# Fire Safety Assessment Report

## **Manila Chemical Company**

Date of Assessment: 27<sup>th</sup> & 28<sup>th</sup> February, 2021

Report Code: FSA-70

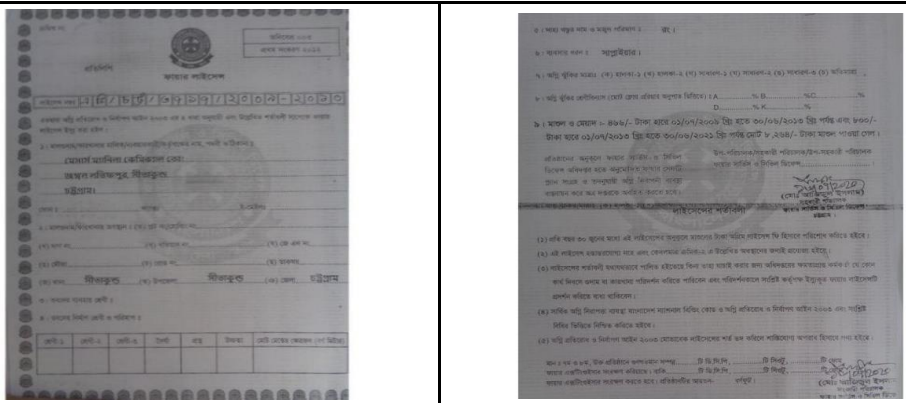
56	Is a Fire Command Station provided at Ground floor in high rise buildings?	NA
Section	Safety Systems	
Description	There was no high rise building in the factory premises.	
Corrective Action Plan		
Reference	<b>BNBC- A.5.5,Page-2945</b>

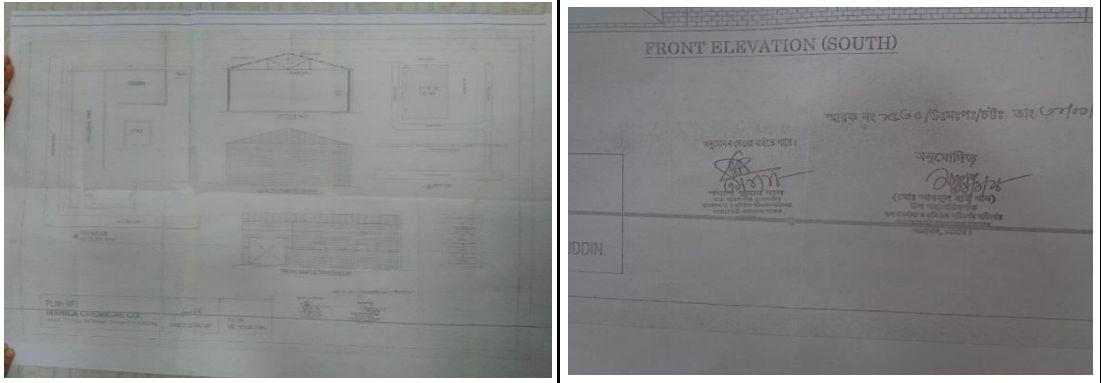
58	<b>Are there combustible materials found near heat/ electrical source (near DB, SDB and electrical installations, loose electrical connection) in store or production floor?</b>	<b>1-2 Weeks</b>
Section	Safety Systems	
Description	During the assessment, combustible materials were found near the electrical source. Location: Production Shed.	
Corrective Action Plan	The factory shall remove all the flammable material in front of the electrical circuitry of distribution panels.	
Reference	<b>Best Practice</b>	
Pictorial Evidence
